DEVIATION REQUEST AND DECISION FORM

Project Name : Paint Brush Hills Fil 14
Schedule No.(s) : 5226101009
Legal Description : TR E PAINT BRUSH HILLS FIL NO 13 E

A deviation from the standards of or in Section **2.3.7.D 1 & 2** of the Engineering Criteria Manual (ECM) is requested.

TYPICAL SECTION – COLLECTOR ROAD

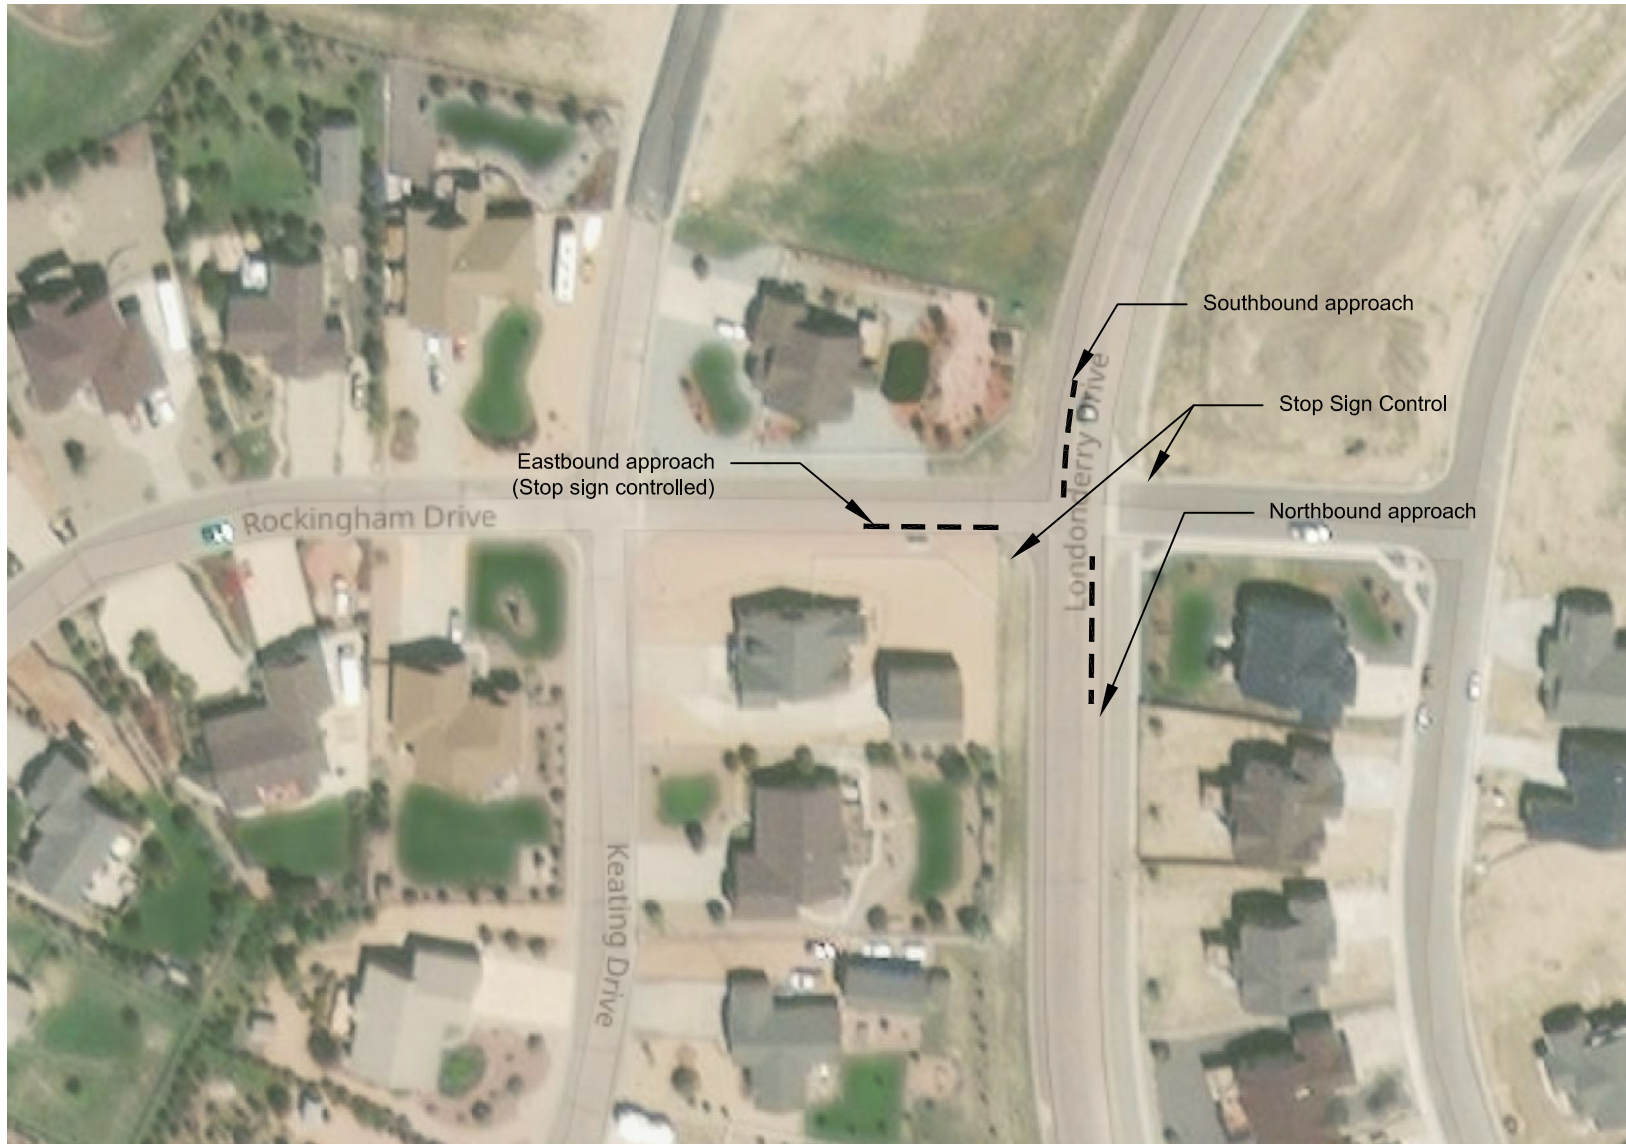
The approved deviation request excludes the proposed alternative for the northbound left-turn (NBLT) lane.

There is sufficient pavement width to install the NBLT auxiliary lane (see cross-section below). The applicant shall provide striped northbound left-turn lane at the intersection of Londonderry Drive and Rockingham Drive per criteria. See ECM Chapter 2 section 2.3.7.E for turn lane design. Note that some striping may need to change at the northerly side of this intersection to keep the lanes in line per criteria.

Exhibit 2

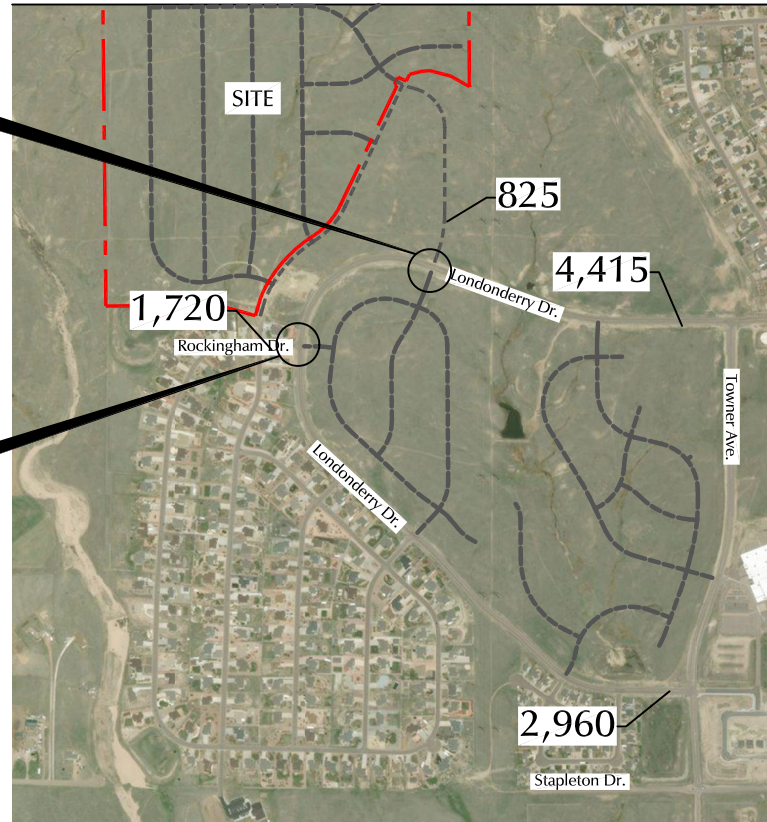
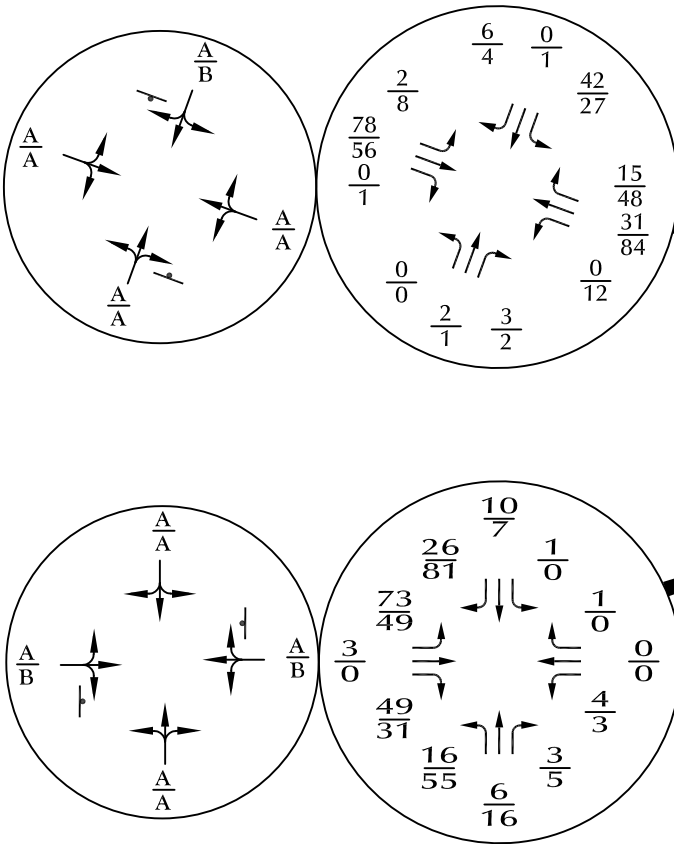
Exhibits 2 and 3 show the projected short-term and long-term traffic volumes at the intersection of Londonderry/Rockingham.

As the west leg (Rockingham Drive) is stop-sign-controlled at Londonderry Drive, and likely will remain so in perpetuity, auxiliary turn lanes will not be needed on this leg for "speed change" or speed differential purposes. As shown on Exhibits 2 and 3, a single eastbound approach lane at this intersection is projected to operate at LOS B or better during the peak hours. The projected 95th percentile queue with a single approach lane is 0.5 vehicles during the morning peak hour and 0.4 vehicles during the afternoon peak hour. This queue can be accommodated by the available 200 feet of stacking distance of between Londonderry Drive and Keating Drive.
